**Los Angeles Unified School District
Office of the Inspector General**

Technical Evaluation

**Pars Arvin Construction, Inc.
and the ADA Improvement
Project at Westchester Enriched
Sciences Magnets High School
Contract No. 4400009903**

**25-0204-TE
July 28, 2025**

Figure 5. DSA Approved Plan C-3.0 Partial Plan for Concrete Ramp #2

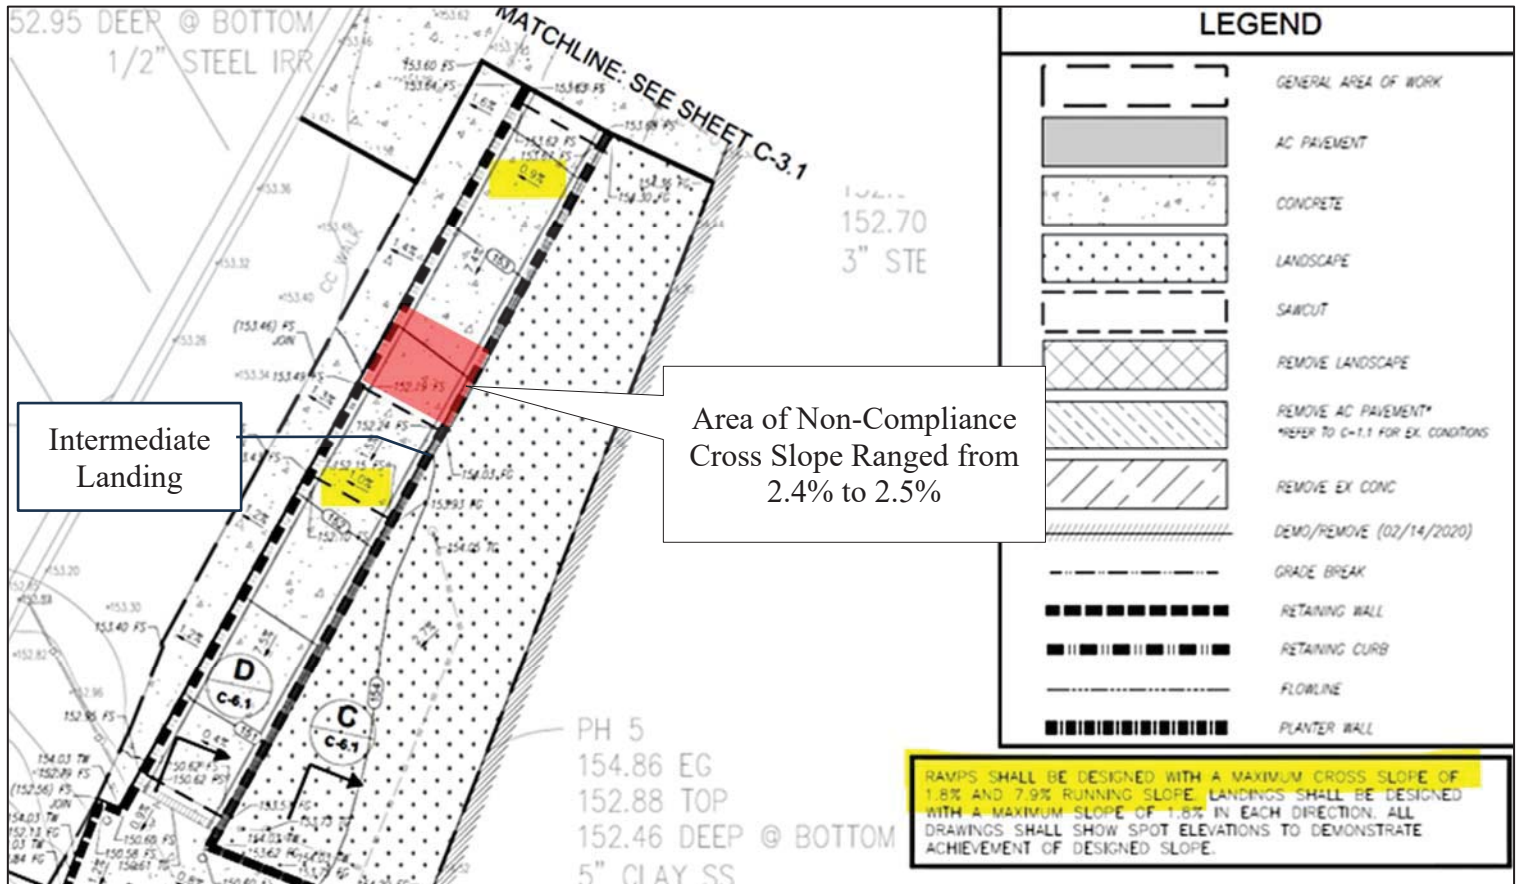
We found that the cross-slope of Concrete Ramp #2 exceeded the allowable limit in certain areas, measuring between 2.4% and 2.5%. According to ADA Standards, the maximum allowable cross slope is 2.08%, while the DSA-approved plan—part of the contract documents—specifies a stricter limit of 1.8%.

According to ADA Standards Section 405.3, ramp cross slopes should not exceed 2.08% (1:48) to ensure safe movement for wheelchair users and pedestrians.⁶ However, measurements taken during our site visits showed that the cross slope of the ramp just above the intermediate landing ranged from 2.4% to 2.5% (Figure 4). Fehoko Concrete Inc., the concrete subcontractor for PACI, was responsible for constructing this ramp. During our site measurement, the owner of PACI, who was present with us, stated that they will have their concrete subcontractor correct the non-conforming cross slope by grinding the concrete surface at no additional cost.

To accommodate field variations, the ADA Standards recommend designing slopes below the maximum limits.¹⁰ Our review of DSA-approved plan C-3.0 confirms that the ADA ramp was designed in accordance with this guidance, with cross slopes less than 2.0%. Specifically, the cross slope at the upper portion of the ramp is 0.9%, and the landing near the non-compliant area is 1.0%. The plan also notes: "*Ramp shall be designed with a maximum cross slope of 1.8% and 7.9% running slope.*" (Figure 5)

Even when considering the recommended 0.5% tolerance, the existing cross slope exceeds the allowable limit. Therefore, we determined that the slope does not align with the ADA Standards nor the contract documents, which were designed with tolerances in mind.

1. PACI should correct the non-compliant cross slope of Ramp #2 to comply with the ADA Standards. Please see OIG's Response below for additional information regarding this recommendation.
2. FSD should inspect and ensure the ramp's cross slope complies with the ADA Standards if/when PACI rectifies the issue. Furthermore, future design plans from FSD for ramp

1. PACI indicated in their response that they are willing to repair the portion of the concrete ramp that is more than 2% and will need to coordinate with LAUSD to do the repair.

FSD disagreed with the finding and recommendations. FSD claimed that the maximum permissible cross slope—when including the accepted 0.5% construction tolerance—is 2.5%. The measured cross slopes of the existing ramp and landing, at 2.4% and 2.5%, do not exceed this threshold and are deemed compliant. FSD conferred with the Office of the General Counsel (OGC) Office of ADA Compliance on this finding, and they also concluded that the work complied with the construction contract, the California Building Code, and applicable federal regulations/guidance. FSD's response included the following assertions.

Moreover, although the OIG recommended that PACI should correct the cross slope of Ramp #2, given FSD's response and differing interpretation and application of the cross slope tolerance, the OIG understands that a correction to Ramp #2 may not be deemed necessary by FSD.

**Figure 8a. Boy's Gym Boy's Restroom Plan
In CCD-A #007**

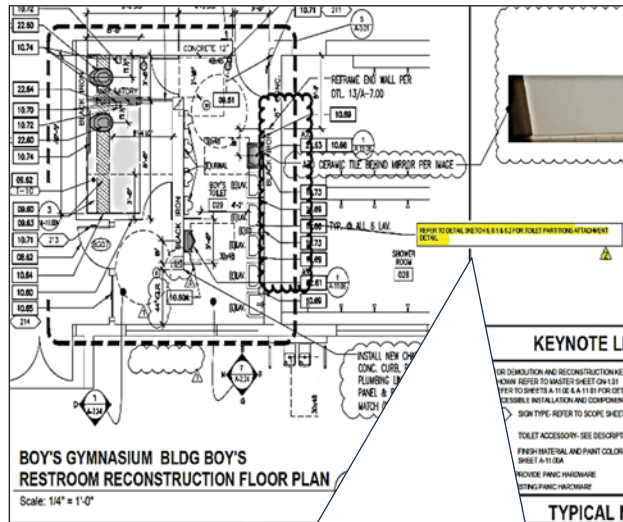
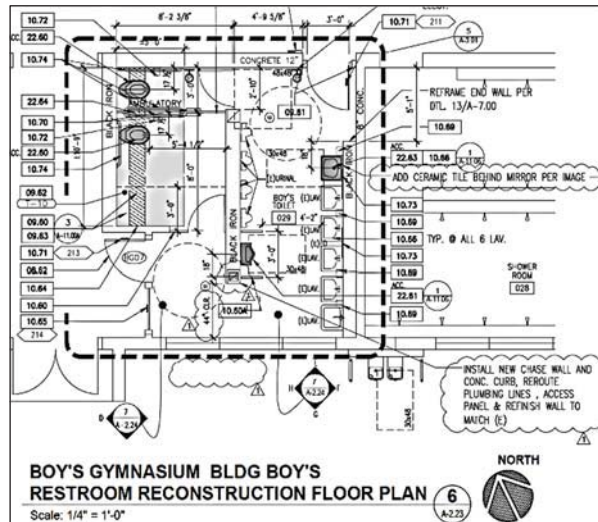
We also found that this project's final record drawings (as-built drawings) did not include the revisions associated with the redesign to address the black iron issues. We reviewed the as-built drawings for the project, retrieved from the LAUSD Drawing Archives (Vault). During our review, we found that four Construction Change Document Category A¹² - CCD-As #007, 008, 010, and 012 – which revised the wall layout to address the black iron issue, were not reflected in the as-built drawings (Figures 8a and 8b). Of the 20 CCD-As issued for this project, only one—CCD-A #017—was incorporated into the as-built set. The as-built drawings should have included all CCDs

These changes to the black iron wall were not reflected in the as-built drawings.

1. To mitigate "black iron wall" issues and improve project efficiency, FSD should enhance initial field assessments, conduct selective pre-construction demolition, and ensure accurate as-built drawing updates.
2. We recommend that FSD ensure the Project Architect updates the project's as-built drawings to incorporate all CCDs, including those related to the black iron issues, to ensure accurate documentation.

- i. **Response:** Facilities Asset Management agrees with the OIG's recommendation. The Westchester HS project was an early Group 6 project (we are currently undertaking Group 20 in 2025). Lessons regarding field conditions have resulted in our current practice of selective destructive demolition testing approach when we suspect that black iron may be in the walls. This is preferably conducted early on in the project prior to or during the design phase of the project to improve the identification of unforeseen conditions ahead of construction.

i. **Response:** Agreed.
